**Watershed Protection and Development Review  
RECOMMENDATION FOR COUNCIL ACTION**

**Subject:** Approve an ordinance waiving the development regulations of Ordinance No. 20060309-058 to allow the construction of a single family residence at 506 Atlanta Street.

## **WAIVER REQUEST STAFF REPORT**

**PERMIT NUMBER:** BP-06-2483R

SEIDER RESIDENCE • 500 ATLANTA STREET • LOT 10/4 • PAGE 1 OF 4

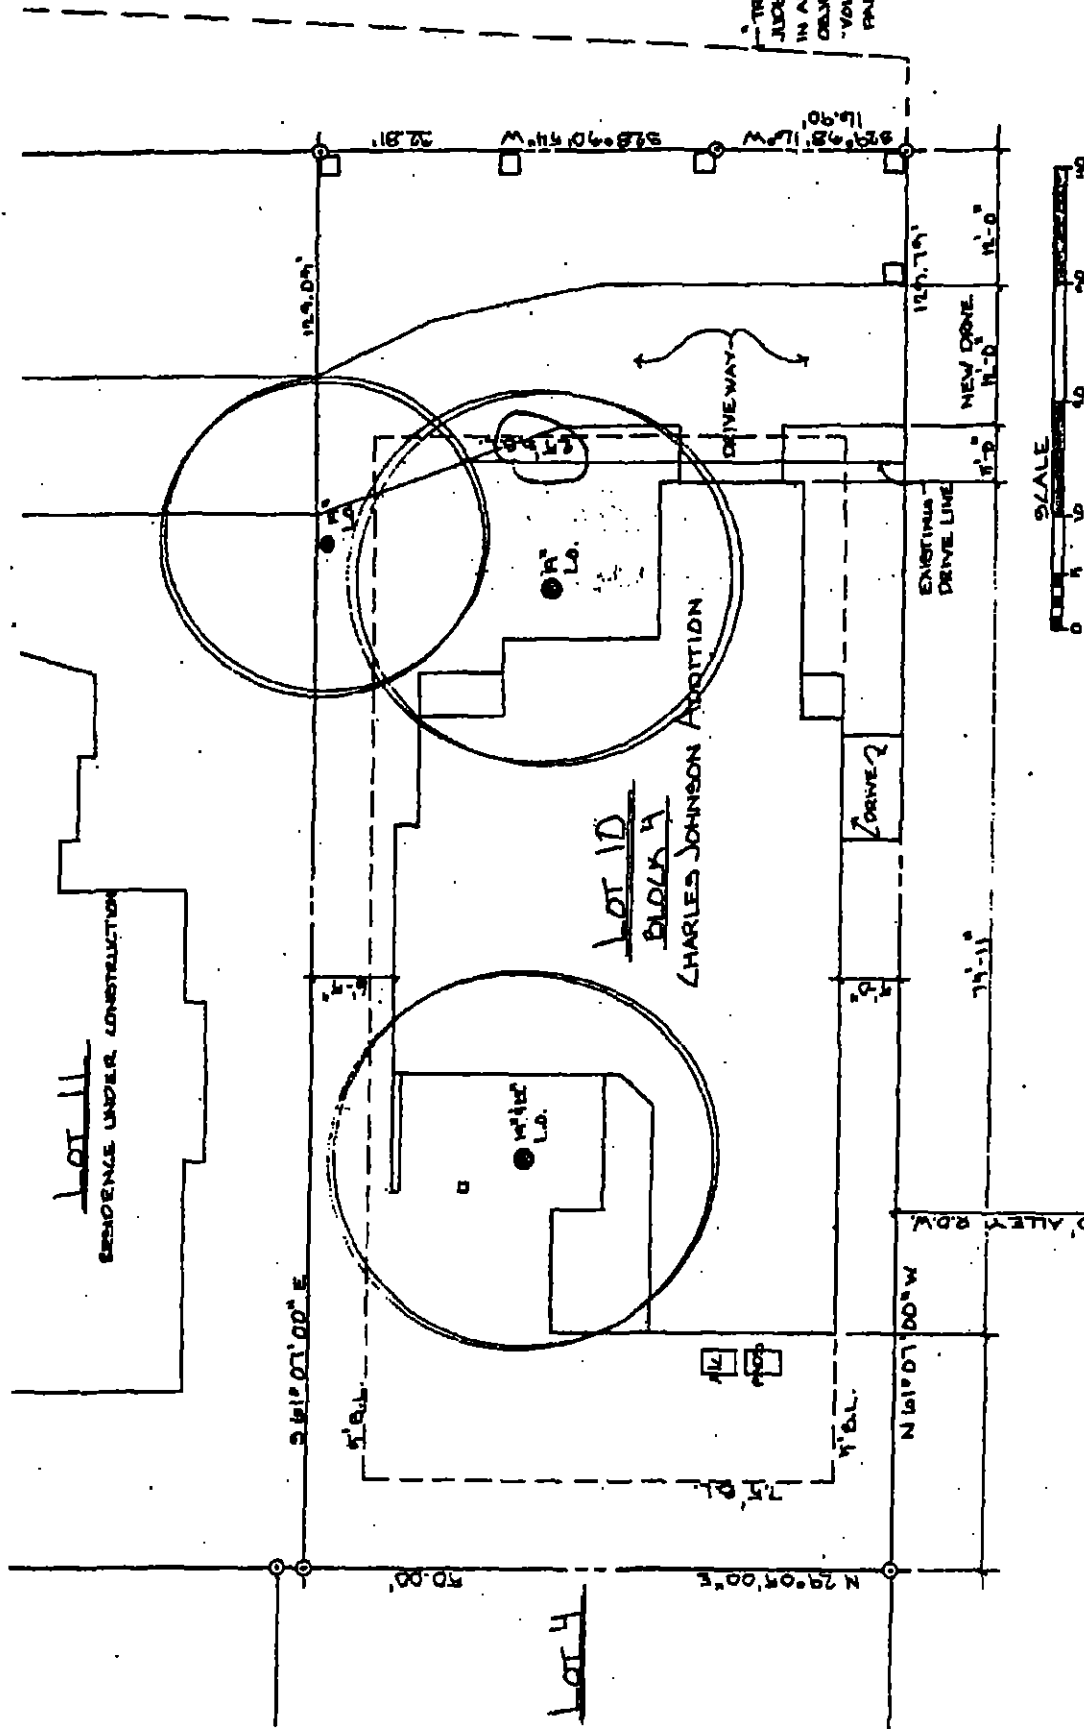
(3) need setbacks along Atlanta at all structures on 66.16

(4) must go to address for address

29' setback proposed, range: 39.65 - 40.5

SHARED DRIVEWAY, LOTS 11-14

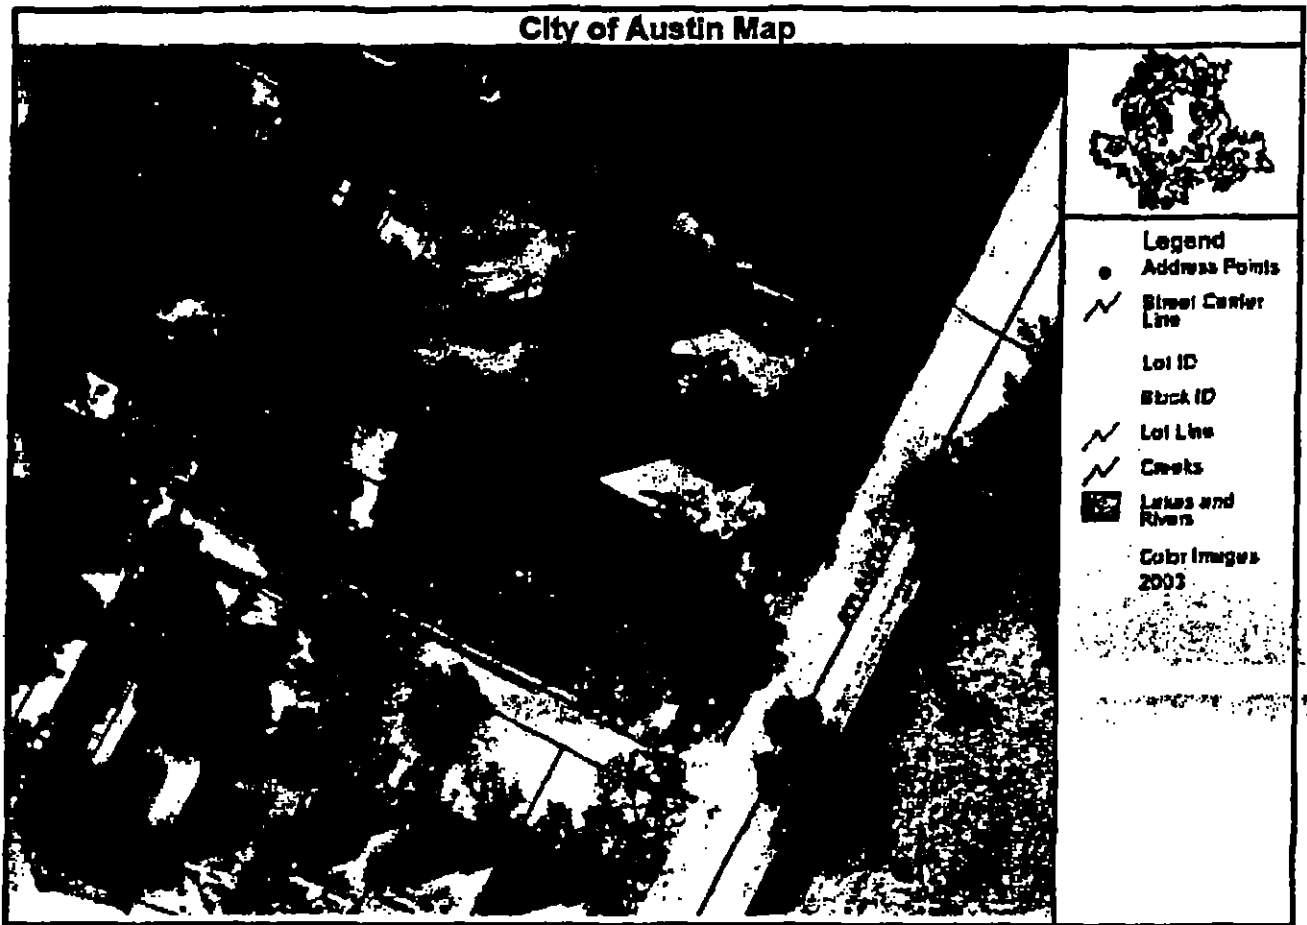
Lot 13 - 518 Atlantic - 40' 6"

Lot 12 - 514 Atlantic - 38' 6"

Lot 11 - 510 Atlantic - 32' 10"

Lot 10 - 506 Atlantic

515 ± 10% min. setback: 34.65  
 106 - 325) max setback: 40' 6"
